**08V-497**  
**(28 pages)**

Safety Defect and Noncompliance Report Guide for Vehicles  
**PART 573 Defect and Noncompliance Responsibility and Reports**

**Ricon Recall Notification (#07E-097)**

## **Safety Standard Non-Compliance Recall Notification - #07E-097**

Placement of Test weight for Anti-Stow  
Interlock Adjustment - Recall 07E-097

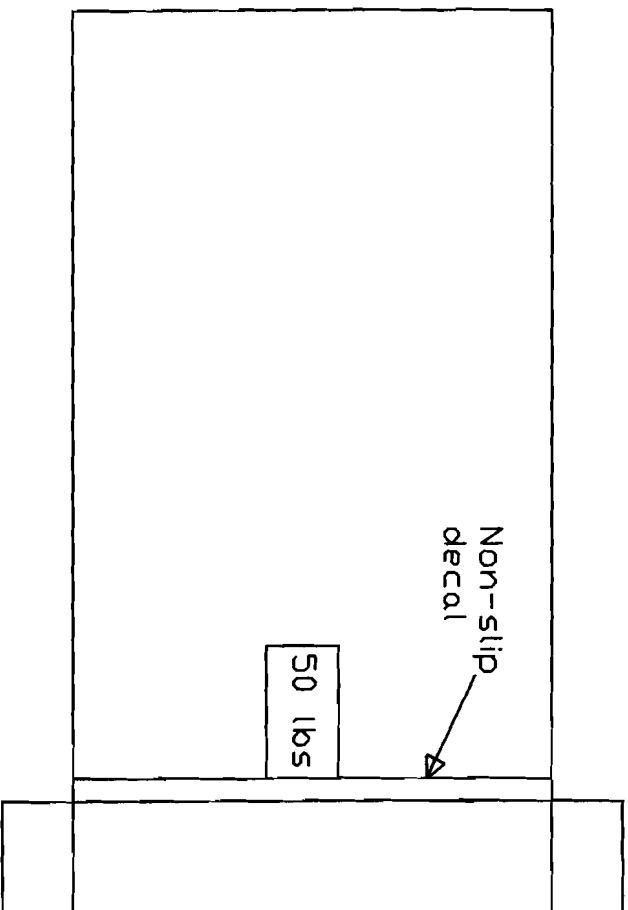
The non-compliance with S6.10.2.3 of the FMVSS 403 is the result of the Anti Stow Interlock not detecting the presence of a 50lb test weight on the inboard end of the platform operating volume. In the event this condition occurs during passenger operations the wheelchair lift may begin to stow while occupied by a wheelchair or mobility aid user. This situation could cause personal injury.

- 1. Park the vehicle in a safe location.**
- 2. Open the lift door(s) and deploy the lift to the floor level position.**
- 3. Place the 50lb test weight oriented lengthwise along the length of the platform and at the most inboard end of the platform operation volume. There is a non-skid decal on the platform that defines this location.**
- 4. Depress the Stow button. Platform should not stow. If platform does not stow, the lift is properly adjusted. If platform stows with the test weigh, continue with the following procedure:**
  - a. Remove the pump cover and locate the anti-stow pressure switch.**
  - b. Remove the "jam" set screw in the center of the switch and turn the adjusting set screw one half turn counterclockwise.**

- c. Place the test weight in the prescribed location.
- d. Adjust pressure switch in the counterclockwise direction until such point where when the Stow function is depressed, the lift will not stow with the test weight in the prescribed location. It is good practice to adjust the switch 1/8-1/4 turn at a time.
- e. Once pressure switch is set, replace the lock screw. Note – When tightening the lock screw, the adjustment screw may turn up to ¼ turn.
- f. Re-test to make sure lift will not stow with test weight in prescribed location
- g. Remove test weight
- h. Depress the stow switch. Lift should stow with empty platform.

**Note – Previous procedures relied on the number of “clicks” heard from the pump solenoid. It is normal for a properly adjusted lift to execute 15 or more “clicks”.**
